Agenda Item # 6

ZON-UDC-002843-2024

B-2, Neighborhood Business Suburban District

Proposal:

SITE PLAN

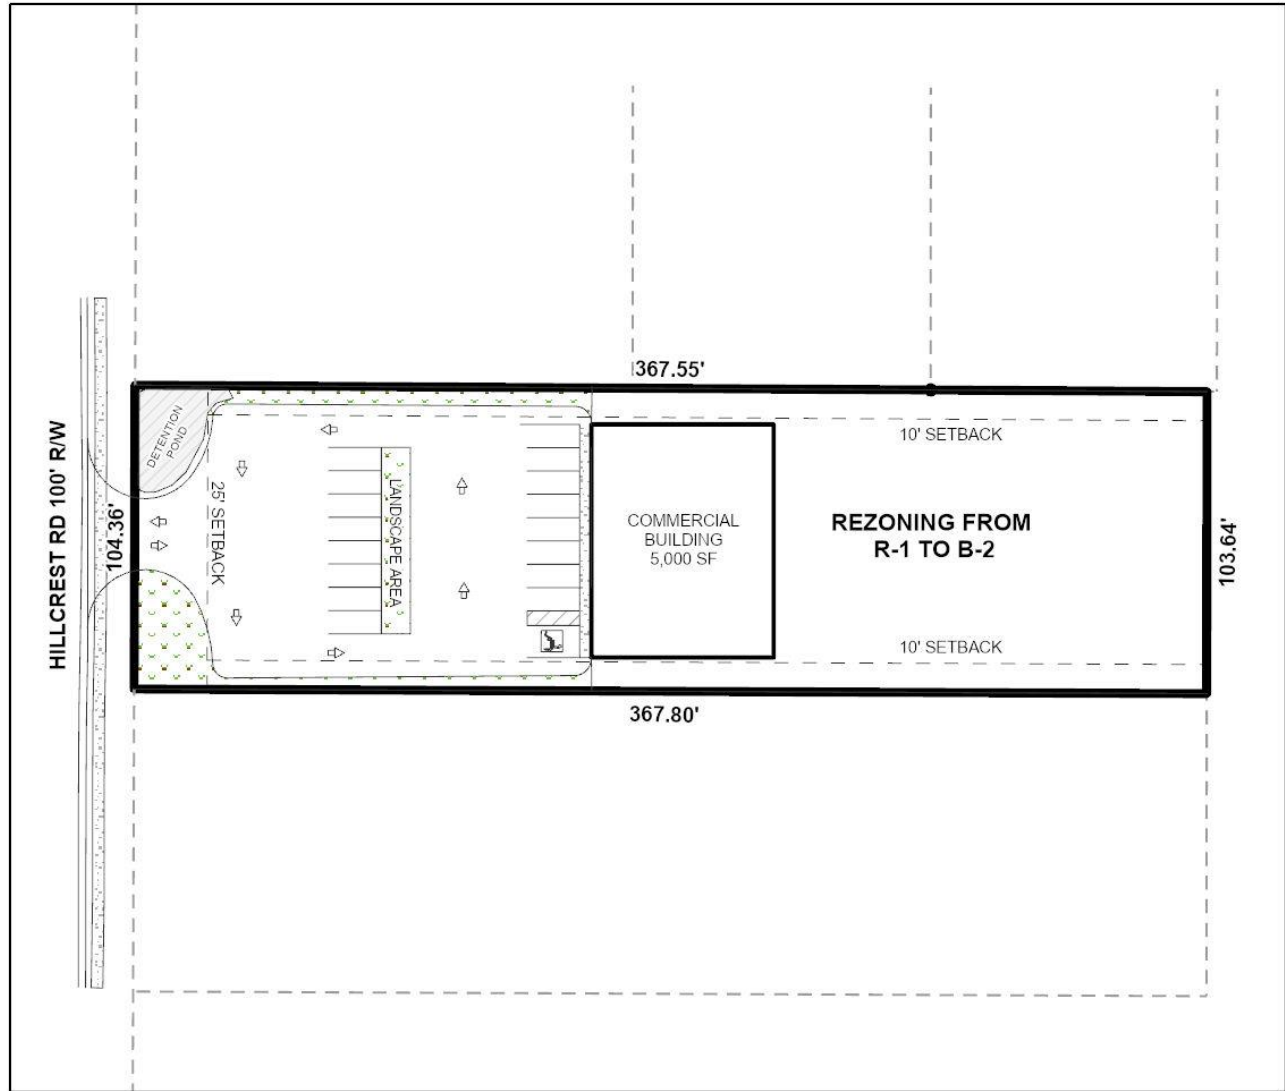
The site plan provided with the rezoning application depicts a commercial building with associated parking. While full compliance with development standards set forth in Article 3 are not depicted, the proposed development will require full compliance with the Unified Development Code (UDC). Any signage placed on the property will also need to meet the requirements of the UDC, and be permitted separately through the Planning and Zoning Department.

1. Compliance with all Engineering, Traffic Engineering, Urban Forestry, and Fire Department comments noted in this staff report; and,
2. Full compliance with all municipal codes and ordinances.
